Application for Planning Approval

DA2025/110

CHANGE OF USE (VETERINARY CENTRE) AND ASSOCIATED WORKS

174 Brighton Rd Veterinary Clinic

PAGE	A03
DRAWING	SITE PLAN

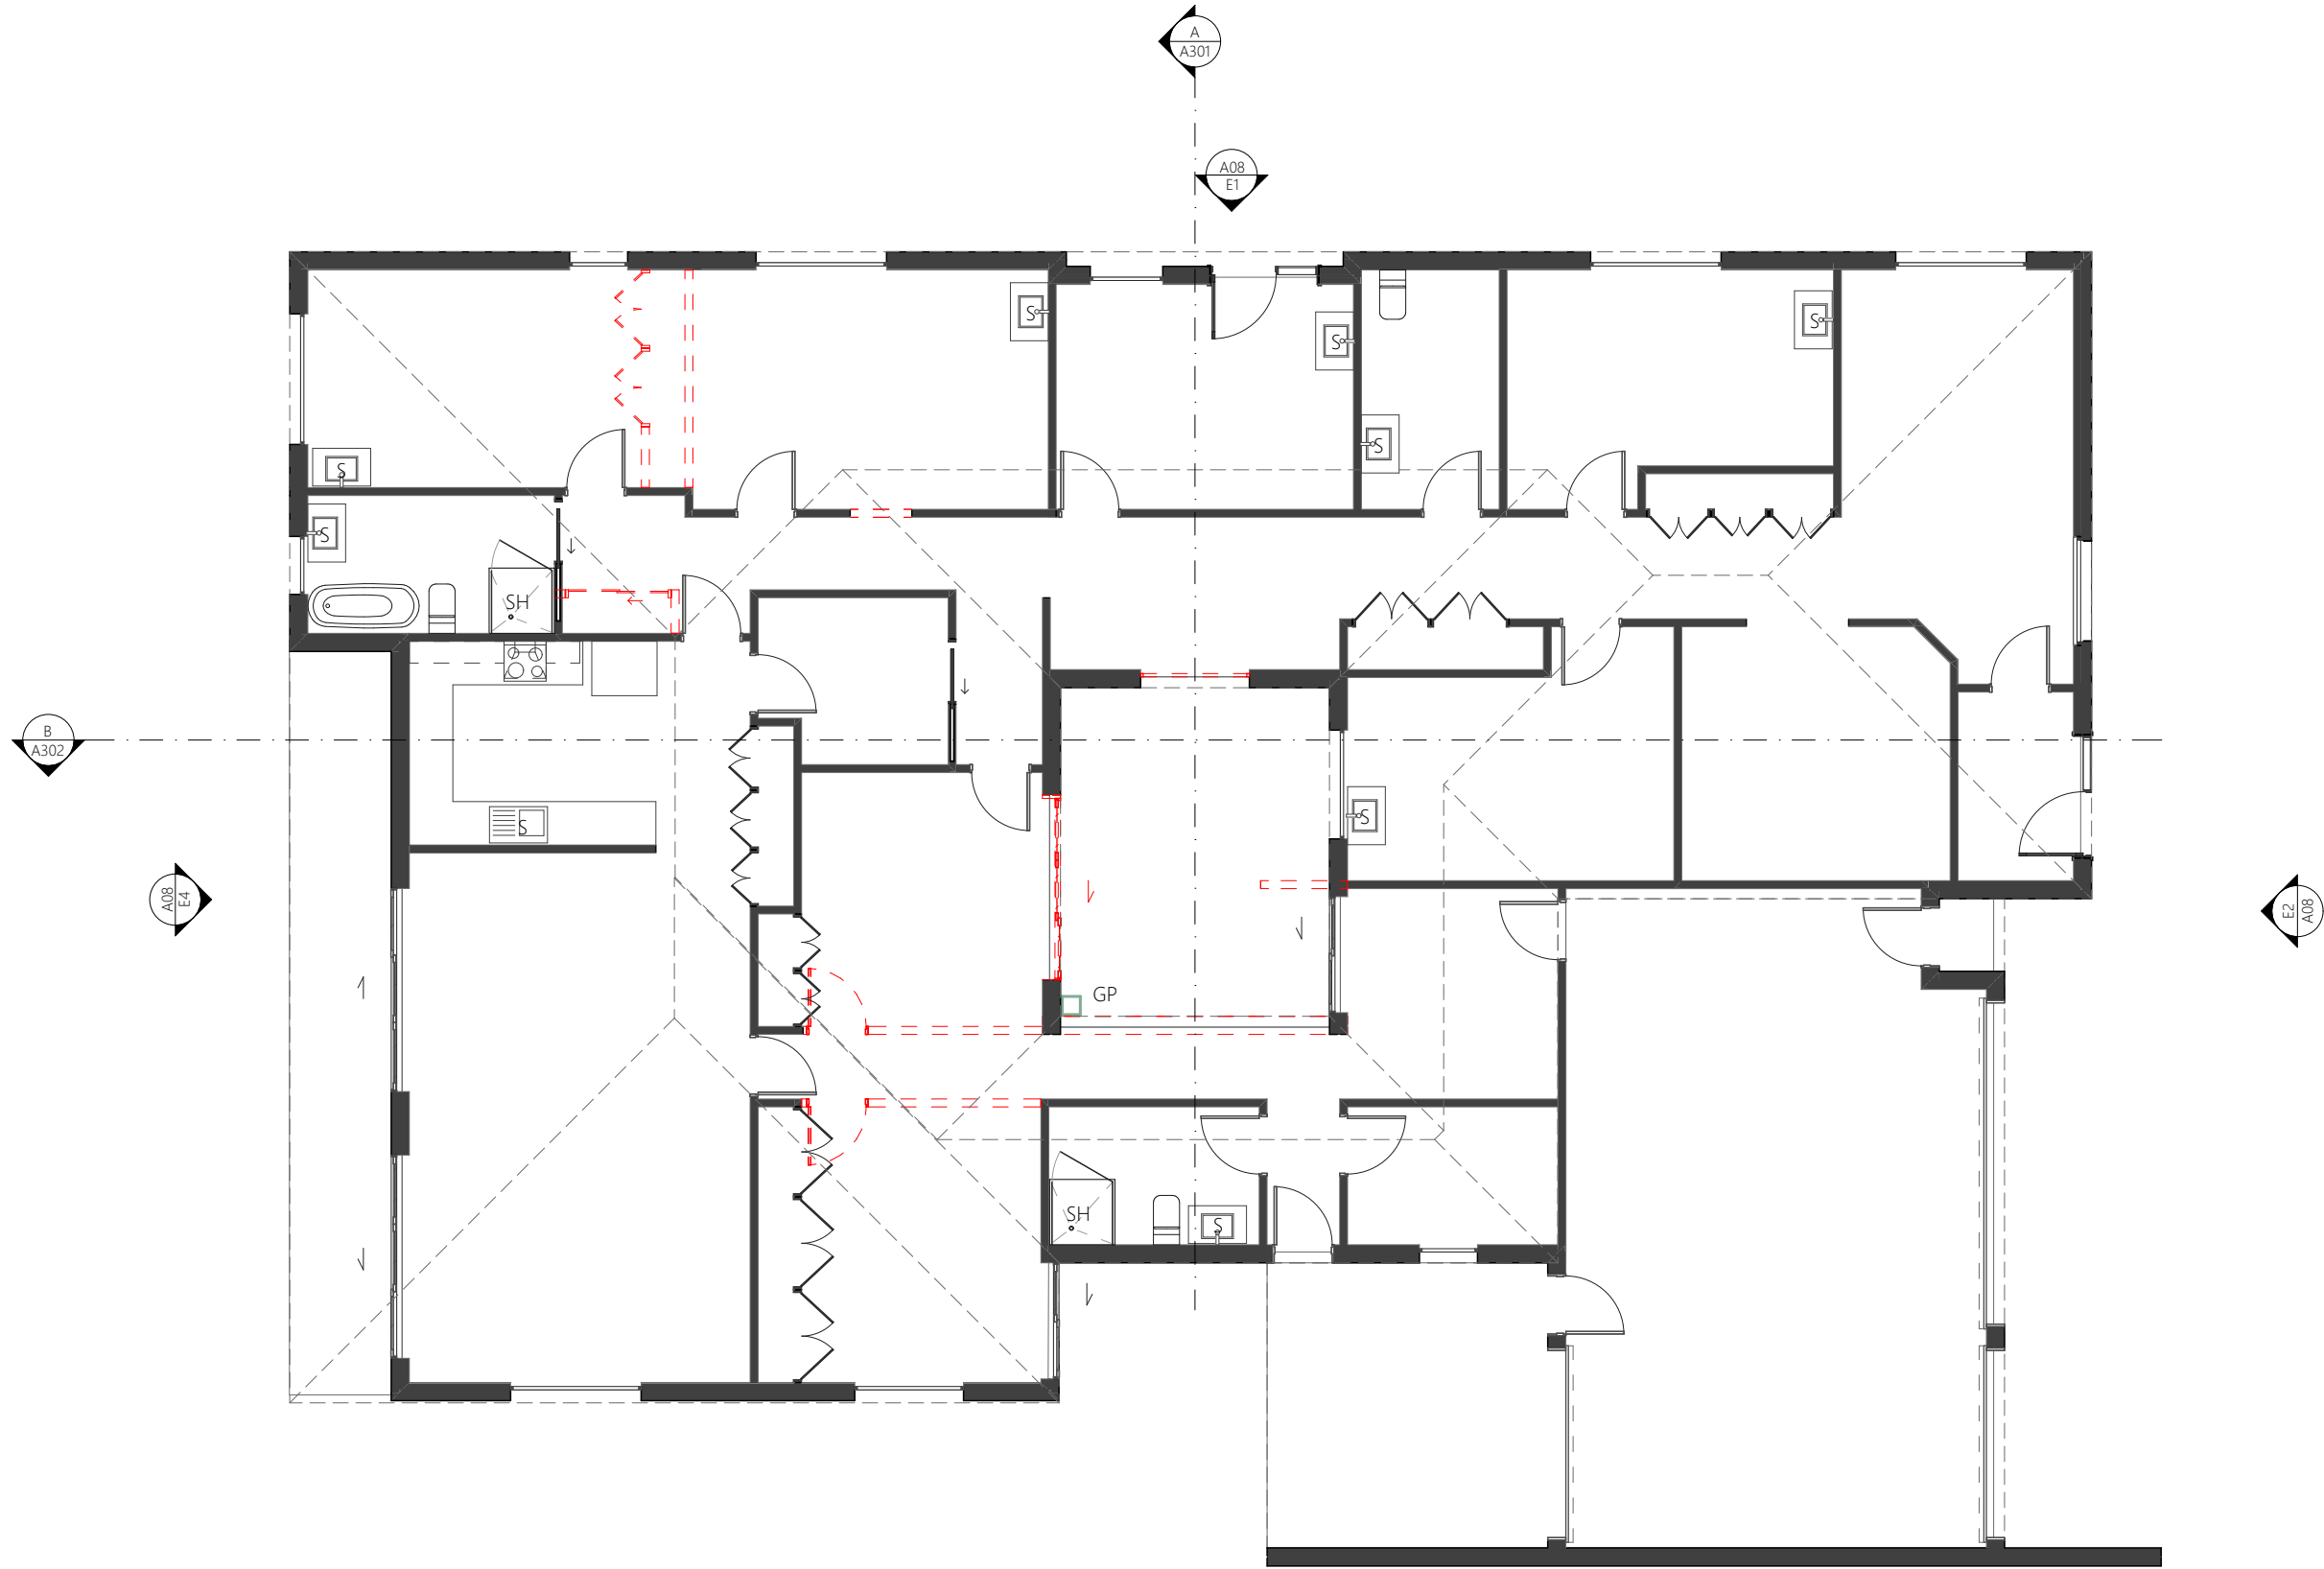
3. Please specify the number of practitioners required for the business, to assist in assessing compliance with the Parking and Sustainable Transport Code.

3. Please specify the number of practitioners required for the business, to assist in assessing compliance with the Parking and Sustainable Transport Code.

The veterinary service will operate with up to four practitioners per day, which under Table C2.1 generates a requirement for 16 car parking spaces (4 x 4 spaces per practitioner).

The current site layout provides 13 on-site car parking spaces, resulting in a shortfall of three (3) spaces. The following response addresses the shortfall against the performance criteria of Clause C2.5.1 P1.1:
The number of on-site car parking spaces must meet the reasonable needs of the use, having regard to:

Clause C2.6.5 requires safe and convenient pedestrian access where more than 10 spaces are provided. As the existing car park does not include a dedicated pedestrian pathway, and modification is not proposed, assessment is made against the performance criteria at C2.6.5 P1.

PAGE
A05
DRAWING
PROPOSED FLOOR PLAN
NORTH
N

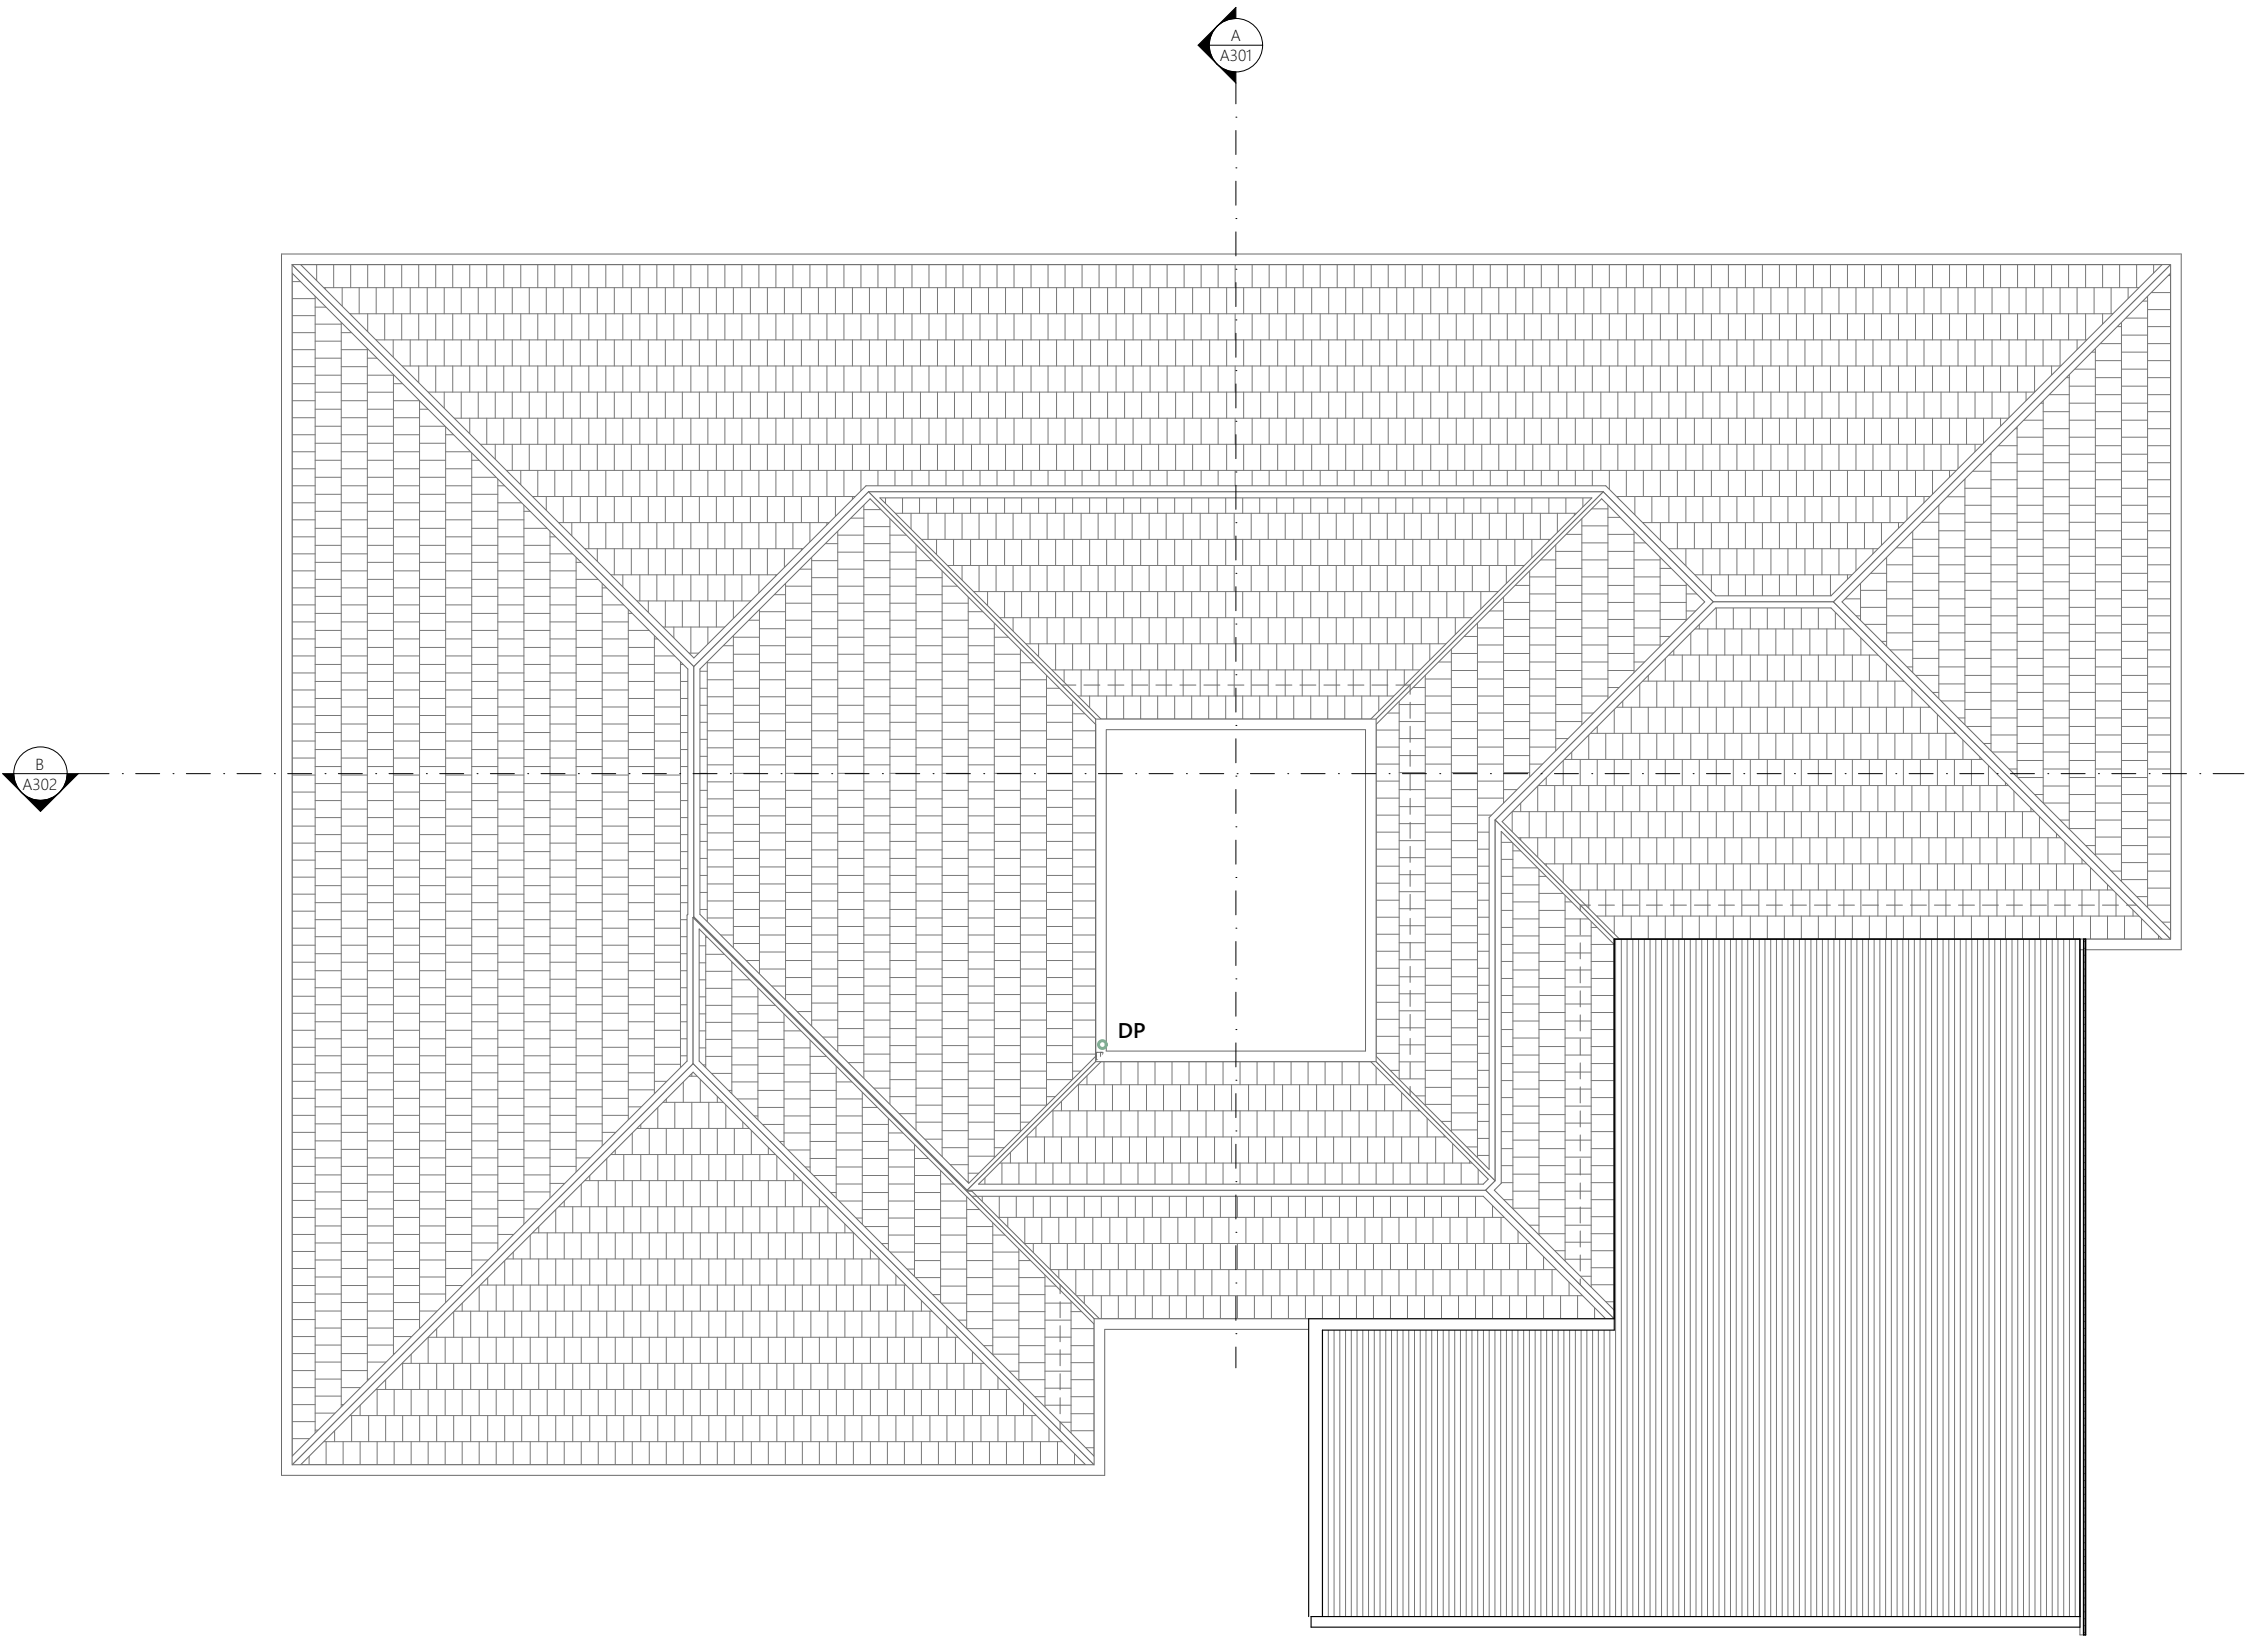
2. Please advise whether there is any external lighting proposed for the use, including security lighting.

A security light will be located at the front of the building in proximity to the main door, this has been shown on the Proposed Floor Plan (A05).
